SUBJECT: ISSUANCE OF AMENDMENT TO UPDATE THE PRESSURE-TEMPERATURE LIMITS
CURVES FOR THE OYSTER CREEK NUCLEAR GENERATING STATION REACTOR
PRESSURE VESSEL (TAC NO. M96405)

Amendment No. 188
License No. DPR-16

ATTACHMENT TO LICENSE AMENDMENT NO. 188

SAFETY EVALUATION BY THE OFFICE OF NUCLEAR REACTOR REGULATION

FIGURE 3.3.1

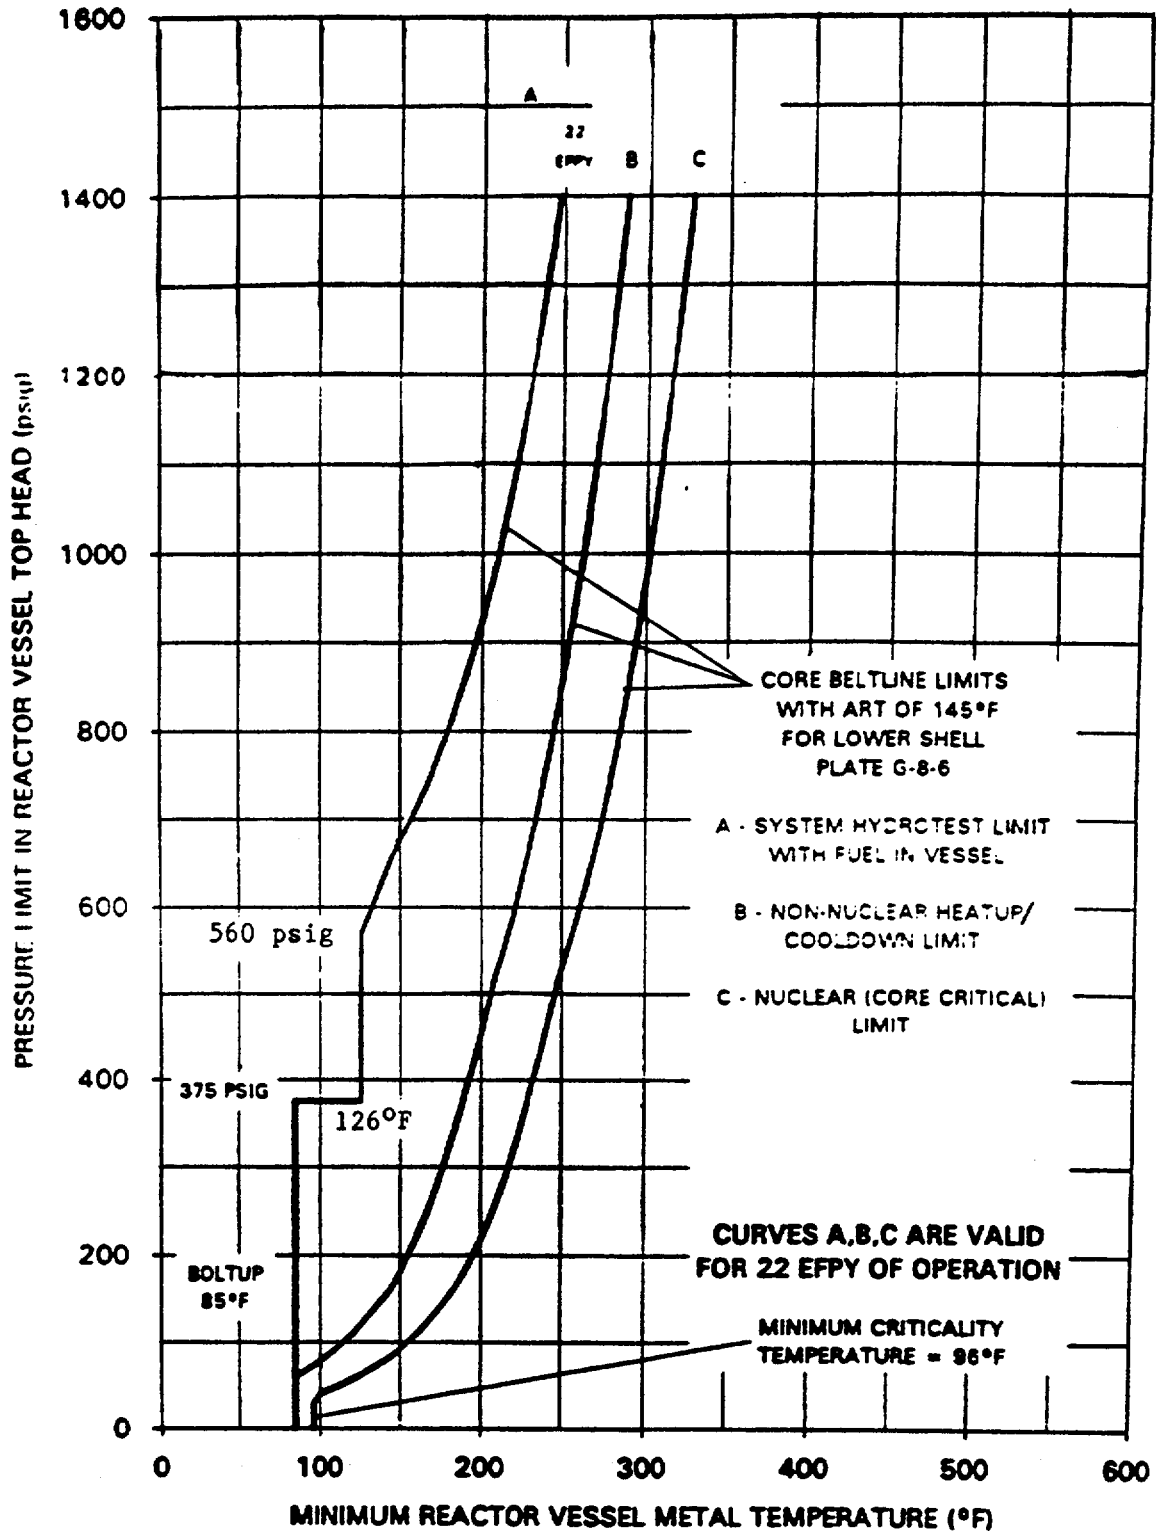
- (i) Reactor Vessel Pressure Tests - the minimum reactor vessel temperature at a given pressure shall be in excess of that indicated by the curve A in Figures 3.3.1, 3.3.2 and 3.3.3 for reactor operations to 22, 27 and 32 effective full power years, respectively. The maximum temperature for Reactor Vessel Pressure Testing is 250°F.

- (ii) Heatup and Cooldown Operations: Reactor noncritical -- the minimum reactor vessel temperature for heatup and cooldown operations at a given pressure when the reactor is not critical shall be in excess of that indicated by the curve B in Figures 3.3.1, 3.3.2 and 3.3.3 for reactor operations up to 22, 27 and 32 effective full power years, respectively.

- (iii) Power operations -- the minimum reactor vessel temperature for power operations at a given pressure shall be in excess of that indicated by the curve C in Figures 3.3.1, 3.3.2 and 3.3.3 for reactor operations up to 22, 27 and 32 effective full power years respectively.

The staff determined that the P-T limits proposed for vessel hydrostatic/leak rate testing by the licensee were acceptable to 22, 27, and 32 EFPYs. The staff also confirmed that the P-T limits curves for 22, 27, and 32 EFPYs submitted by the licensee for normal operation under core critical and non-critical conditions were consistent with those generated using the methodologies of SRP Section 5.3.2 and Appendix G of the ASME Code. In addition, normal boiling water reactor operations are constrained to saturated water conditions, and these conditions are very conservative with respect to the normal operation limits as calculated by the acceptable methodologies listed above.
